BP - Toddler Beds Final Rule
 The contents of this document will be
 discussed at the Open Commission
 Meeting on March 30, 2011.

SUBJECT : Final Standard for Toddler Beds under Section 104 of the Consumer Product
 Safety Improvement Act

Staff Briefing Package
Draft Final Rule for Toddler Beds
March 2011

FIGURE 11 -- Guardrail Structural Integrity Test

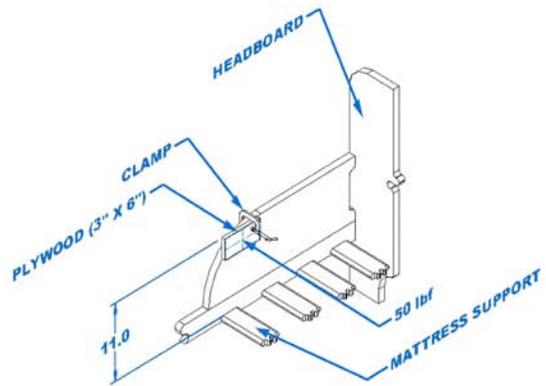
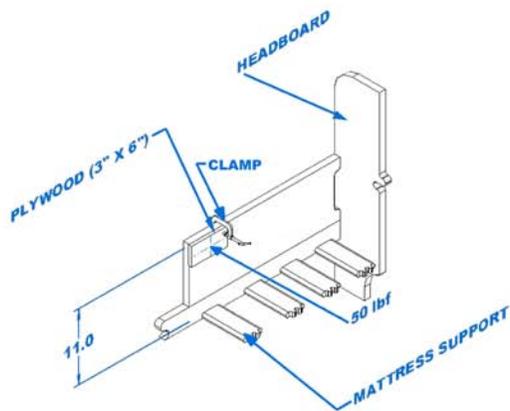
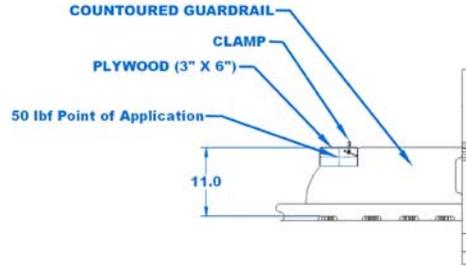
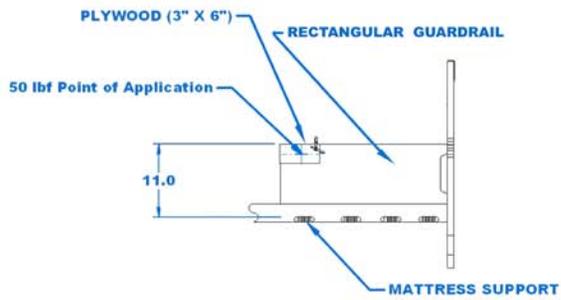
Once the force limit is determined it remains necessary to have a clearly defined testing methodology. Technical issues regarding have been addressed in the ASTM Standard, but are not adequately or consistently referenced in the NPR. Clarity is required as regards the specific test methodology to be employed. Some of our members have noted that questions exist about the need to require that the guardrail be tested in 3 places, instead of just at the most onerous point. Also the proposed regulation states to do the test “*above the leg of the guardrail*”, what if there is no “*leg*”? What about the case of a guardrail that has a contoured upper surface or one which is integral with the sides of the bed? Clearly the test method needs to specify the contact area of the force and how far from the top of the rail this force should be applied. Also the height of the bed rail should be fixed or measured from the mattress support platform so there will be consistency of measurement². We recommend that the test methodology as specified in Appendix A supplied with these comments simply be incorporated fully by reference. Similarly, the wording in the NPR in section 6.1.1 is not clear in that it states “*....that allows complete passage of the wedge block,*” referencing the mattress support and not the opening above the mattress support between the mattress and bed side or end. This section reads as if the mattress must be contained. Section 8.4.4.2 also references mattress containment in labeling. These sections need to be addressed for clarity before the Standard is enacted. Whether the mattress must actually be contained within the toddler bed prior to application of testing needs to be clarified. Clearly when possible, consistent requirements between product categories should be carefully reviewed, prior to adoption.

ASTM F 1821 – 09 Section #	NPR Language	Draft Final Language
No section in ASTM	7.9 <i>Test Method for Guardrail Structural Integrity</i>	No changes from NPR
No section in ASTM	7.9.1 Firmly secure the toddler bed on a stationary flat surface using clamps. Gradually apply 50 lbf to the uppermost horizontal part of the mattress side of the guardrail in a direction perpendicular to the plane of the rail. The force should be applied in the center along the length of the rail and then repeated with the force applied directly over each of the outermost legs of the guardrail. The force should be applied in the direction away from the mattress within a period of 5 s and maintained for an additional 10 s.	7.9.1 Firmly secure the toddler bed on a stationary flat surface using clamps. Gradually over a period of 5 s apply a 50 lbf (222.4 N) to the guardrail from the inside of the toddler bed, outward and perpendicular to the plane of the rail, and hold for 10 s. The force is to be applied to the geometric center of a 3 x 6 x ½ in. (7.62 x 15.24 x 1.27 cm) piece of plywood with the long end parallel to the floor (see Fig. 11).

Figure 1: “FIG. 11 Guardrail Structural Integrity Test”

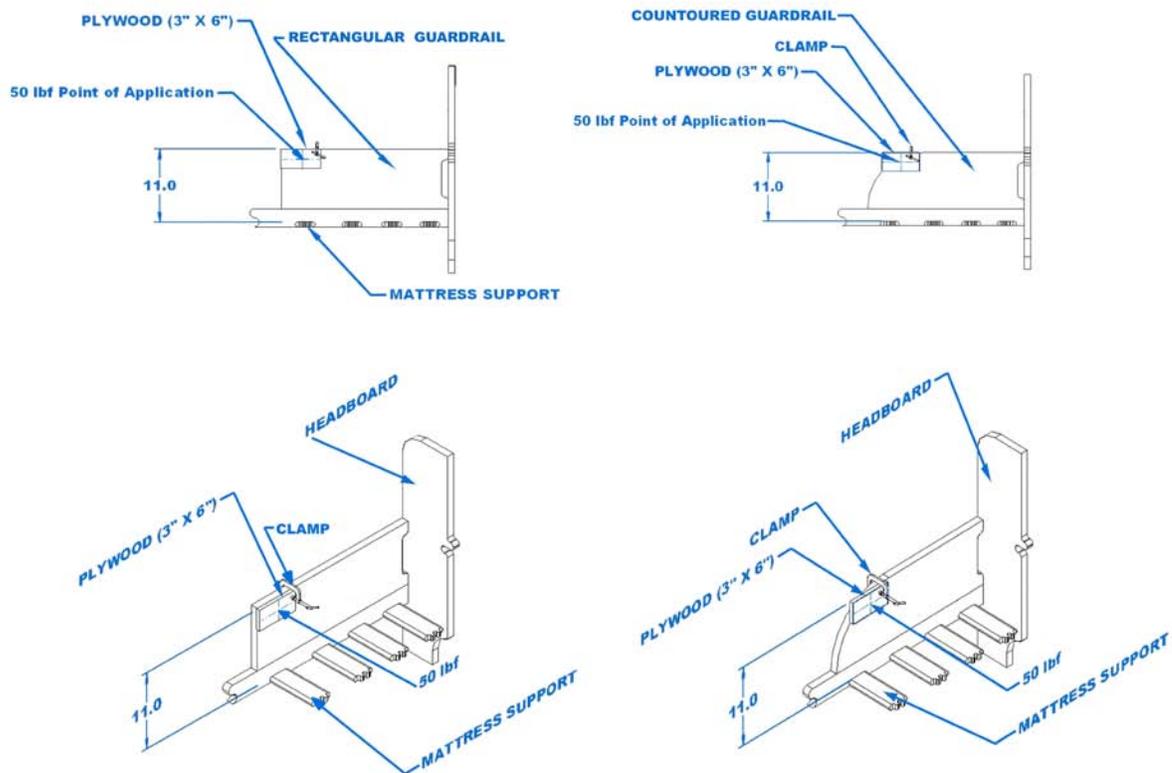
Despite receiving a comment that did not agree with the proposed guardrail height and structural integrity performance requirements, staff continues to recommend the proposed guardrail height of 5 inches above the sleeping surface and the application of 50 lbf for the structural integrity test. Staff does recommend modifying the test methodology for improved test repeatability, as

suggested by one commenter. Staff also recommends including a figure depicting the guardrail structural integrity test in the final rule, as shown in Figure 1.
